ADDENDUM

Addendum No. 2

The State of Connecticut
Department of Housing (DOH)
Community Development Block Grant
Disaster Recovery Program (CDBG-DR)
Owner Occupied Rehabilitation and Rebuilding Program (OORR)

Application No. 1743
Flynn Residence
50 Mumford Cove Road
Groton, CT 06340

ASK-01a

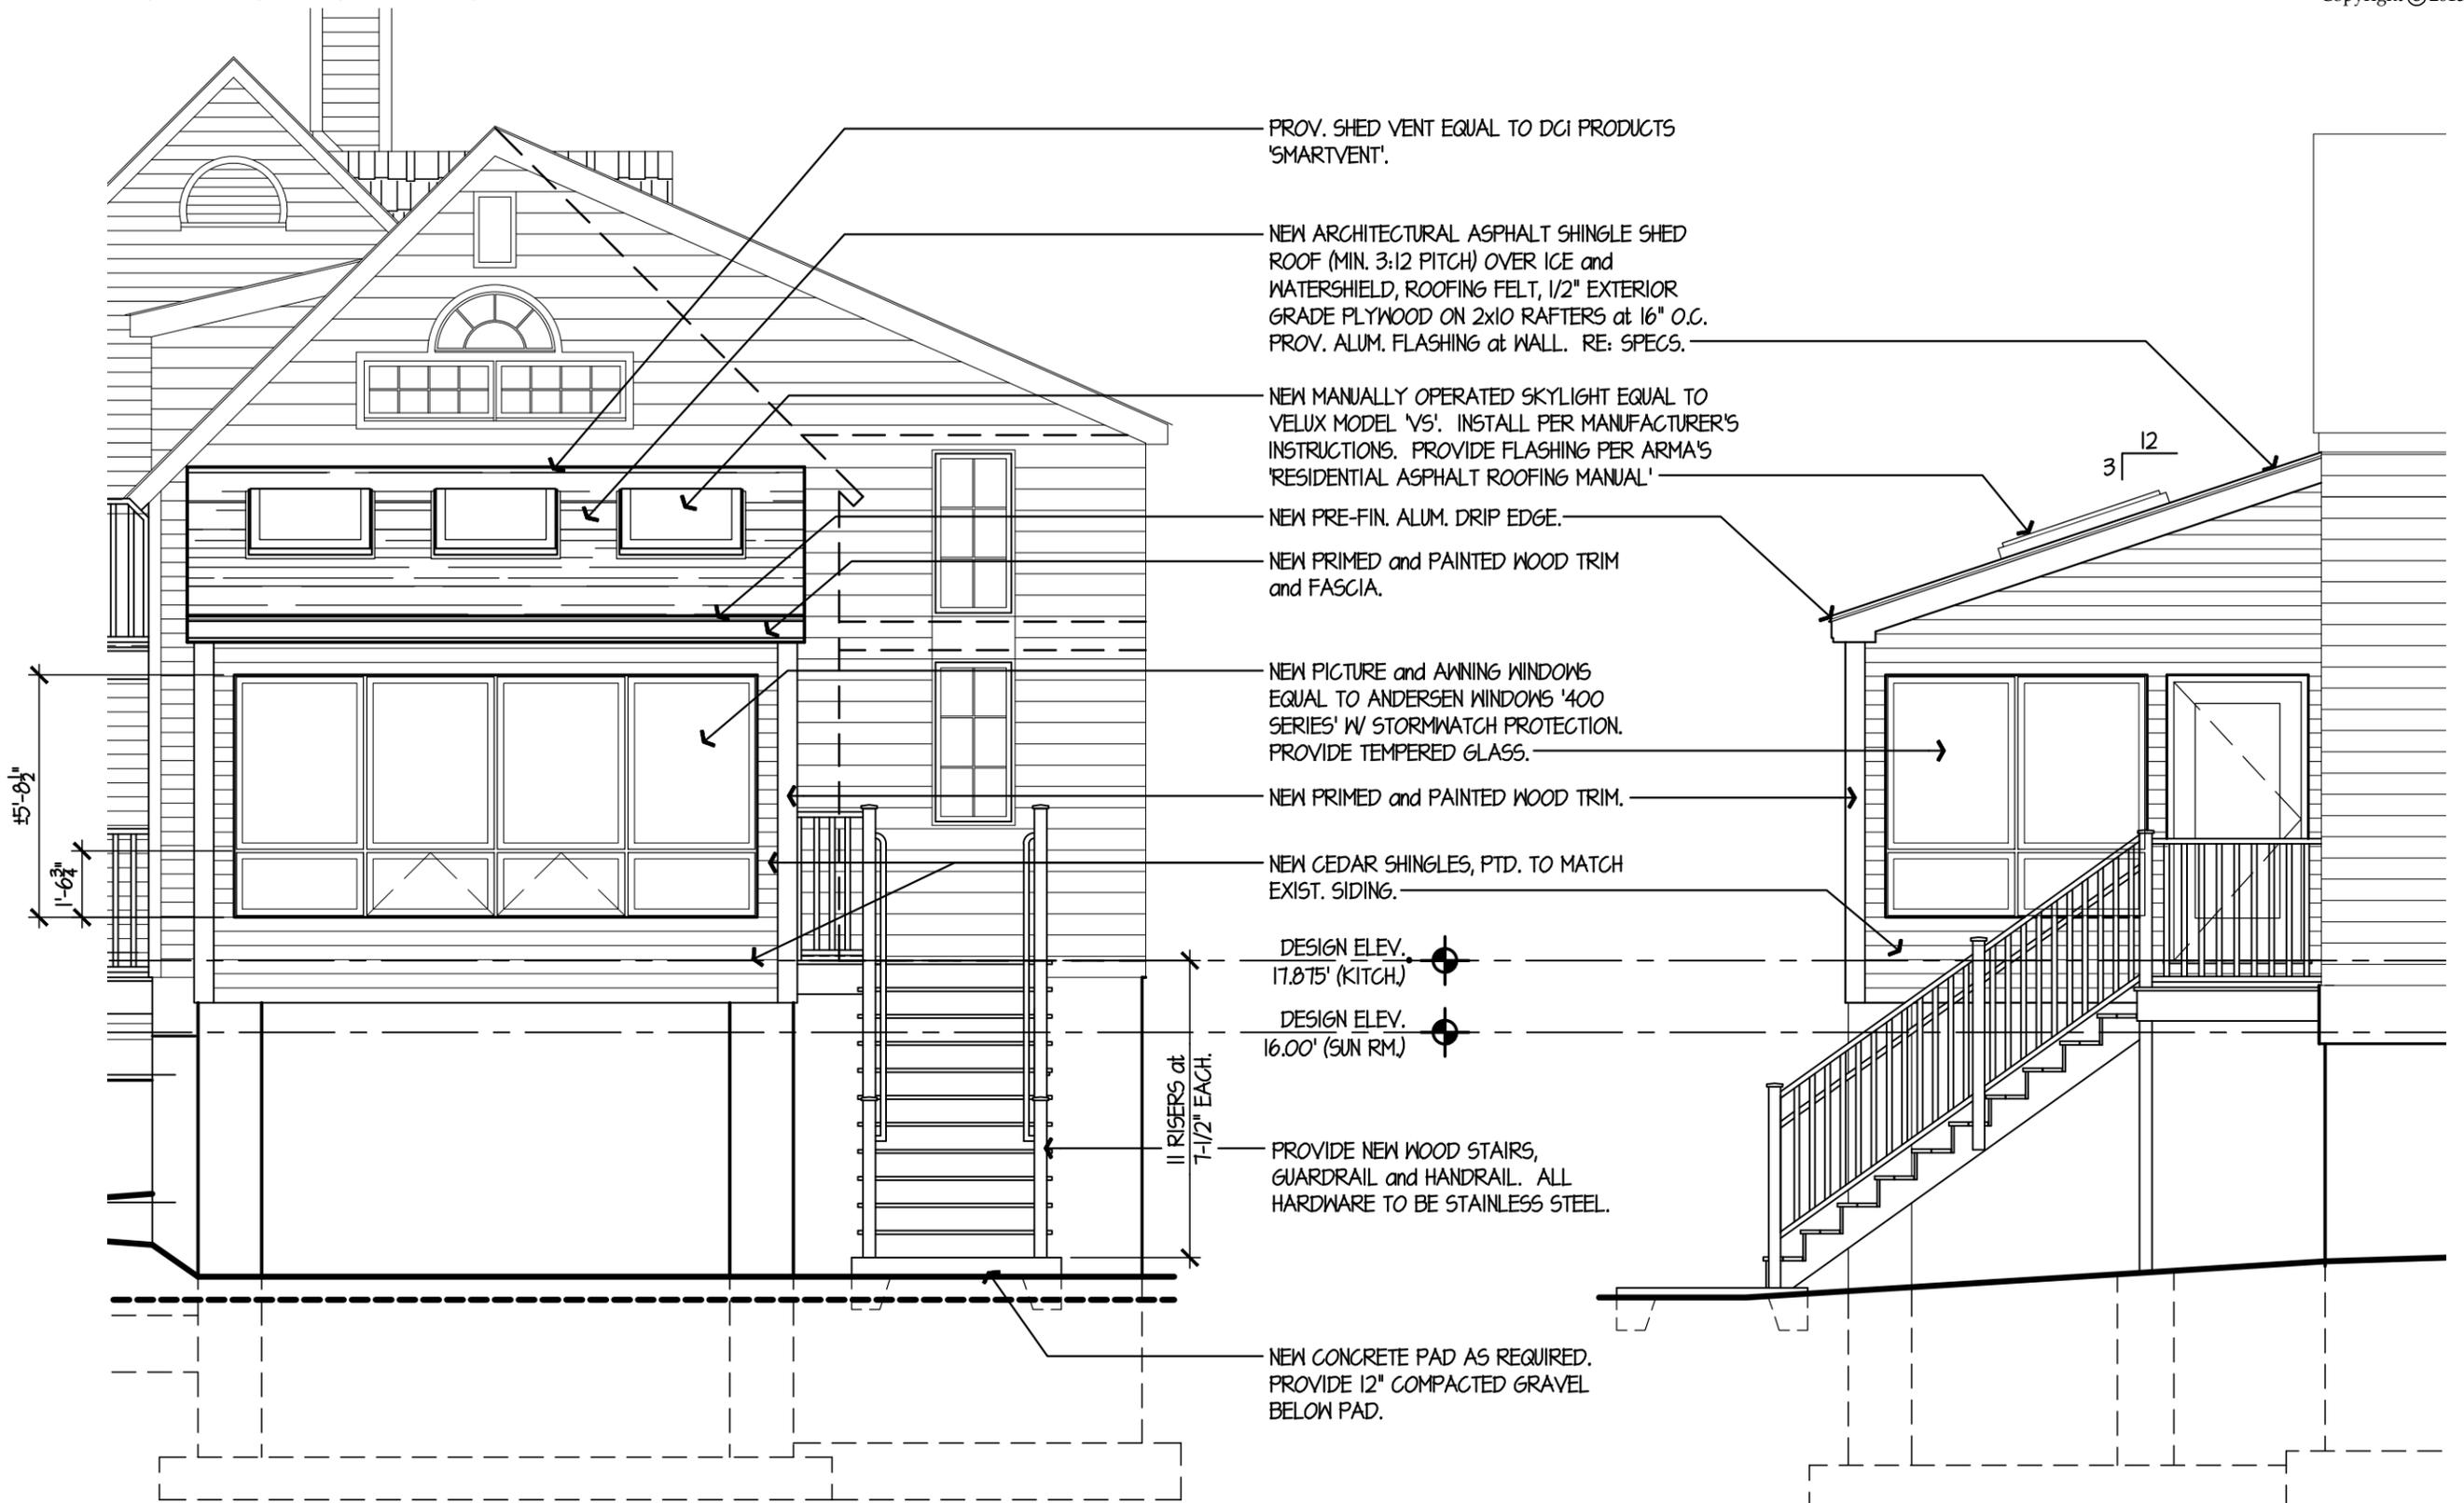
1. Refer to ASK-01a, ASK-01b and SKS-01 for Drawings related to Alternate No. 1 as identified in Specification Section 01230 - Alternates.

- A. Alternate No. 1 – Conventionally framed sunroom in lieu of pre-fabricated sunroom. Refer to ASK-01a, ASK-01b and SKS-01
1. Cedar wood siding to match existing house, 1/2" exterior plywood sheathing, 2x6 wood framing, R-21 batt insulation, 1/2" painted moisture resistant GWB, primed and painted wood base and trims.
 2. 30 year asphalt shingle roofing with ice and watershield, roofing felt, 1/2" plywood sheathing, 2x10 roof framing, R-30 (8-1/4") batt insulation and 1/2" painted moisture resistant GWB.
 3. Galvanized hurricane clips, anchors and fastenings.
 4. Andersen 400 Series windows with Storm Watch protection.
 5. Velux VS skylight.
